## 12.3 Radiation Protection Design Features

The information in this section of the reference ABWR DCD, including all subsections, tables, and figures, is incorporated by reference with the following departures and supplements.

Figure 12.3-74 Upper Drywell Shielding Radiation Dose Rates with Fuel Bundle on Refueling Bellows (Gy/h)

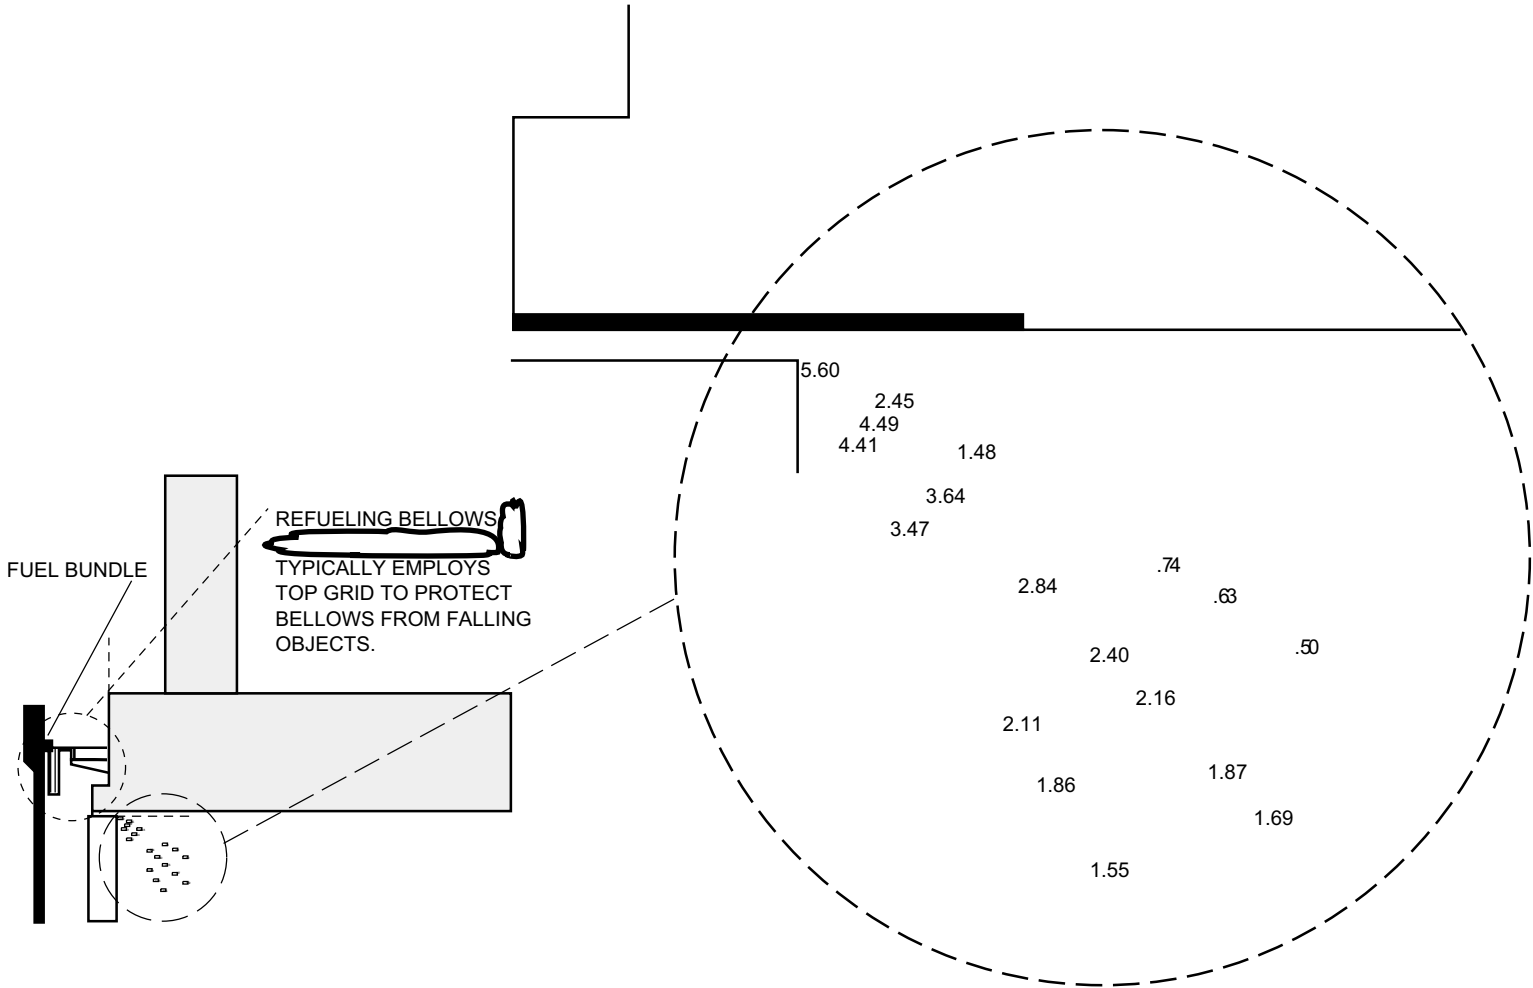
STD DEP Admin (Figures 12.3-1, 12.3-3, 12.3-6 and 12.3-74)
